HARTING Product Change Notification

PCN/23/008/C+N

Title: Han(R) TC70 Contact 2,5-16mm² - External

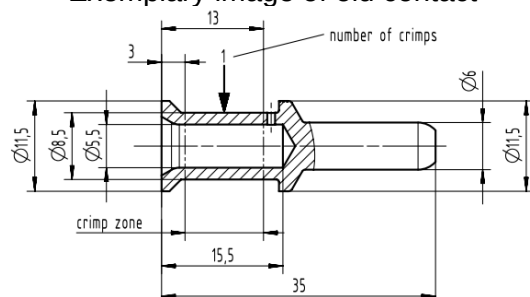
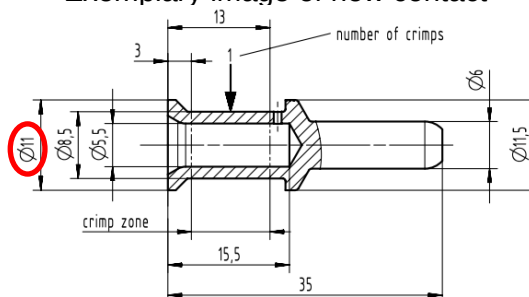
The outer diameter of the Han® TC70 contacts 2.5 – 16 mm² will be reduced from 11.5 mm to 11.0 mm on the termination side only.

The outer diameter 11.5 mm on the mating side and all other dimensions remain the same.
